Ruth ISL R&D

Docket Number #40-8783

License Amendment

Restoration Plan

URANERZ U.S.A., INC.		
RUTH ISL PILOT PROJECT		
PROPOSED STABILIZATION MONITORING WELLS		
GEOLOGICAL	SCALE: 1" = 20'	FIGURE:
DRAWN BY: P.S.	DATE: 8-15-83

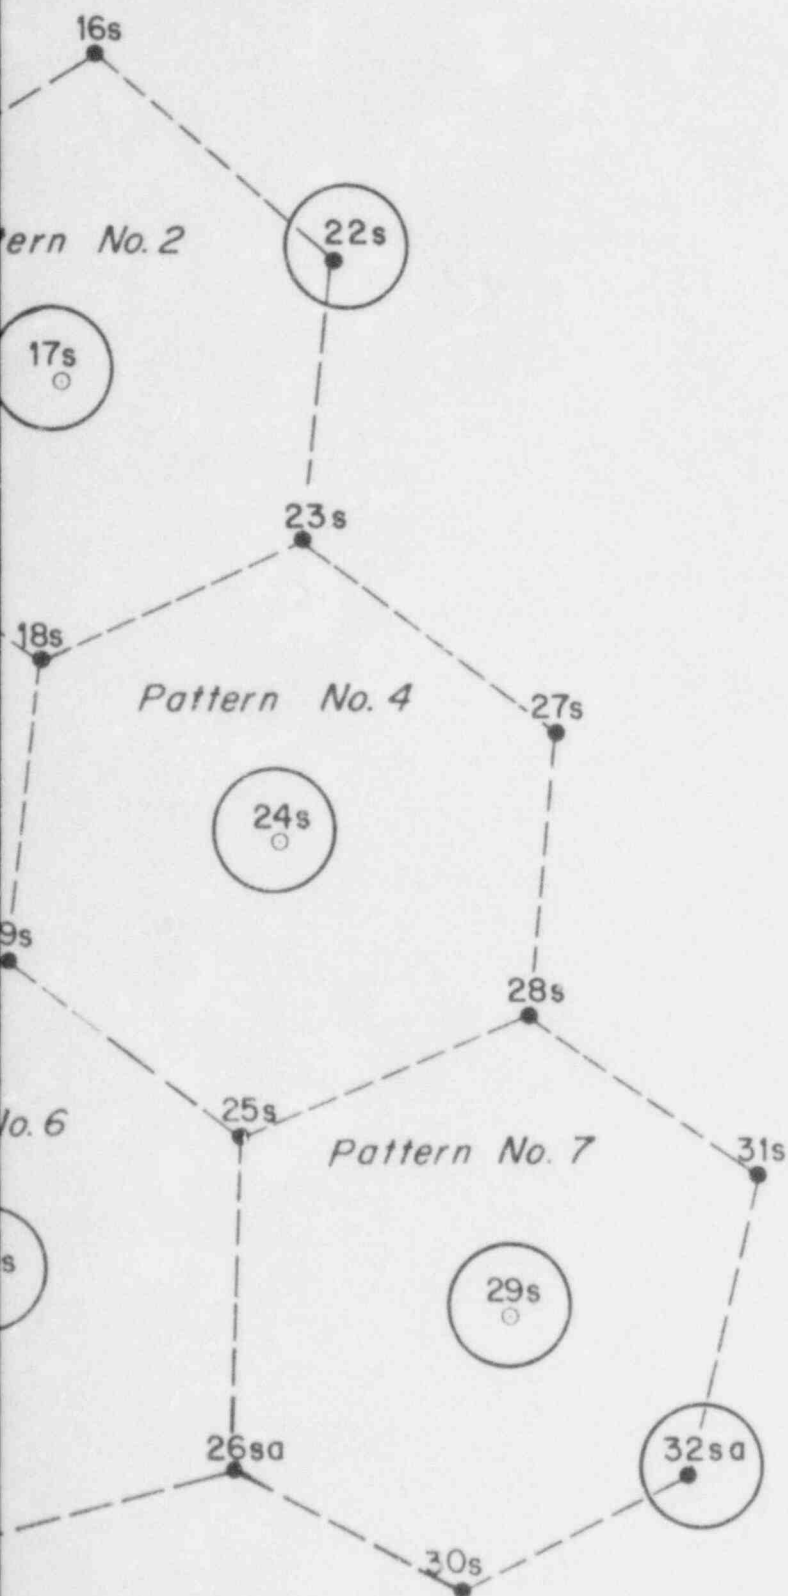
(1) Number of Wells - License Stipulation #15 states that "the monitoring plan shall consist of water sampling and analysis of all leaching well, including any monitoring wells affected by mining operations." This requirement totals at least thirty-two (32) wells in less than one sixth (0.6) of an acre, which is excessive in terms of data collected and cost to obtain that data. Therefore, Uranerz is submitting the following changes and amendment to this stipulation.

Uranerz is proposing to reduce the thirty-two wells down to approximately one-third or eleven (11) wells that will be sampled on the stipulated schedule of once every month during the stablization period and analyzing them for the full suite of baseline parameters.

The wells being proposed as sample wells are as follows:

- 7 Recovery Wells (Center of Each Pattern)
- 4 Designated Wellfield Parameter Wells

These wells are labeled on the enclosed map. (Figure 1)
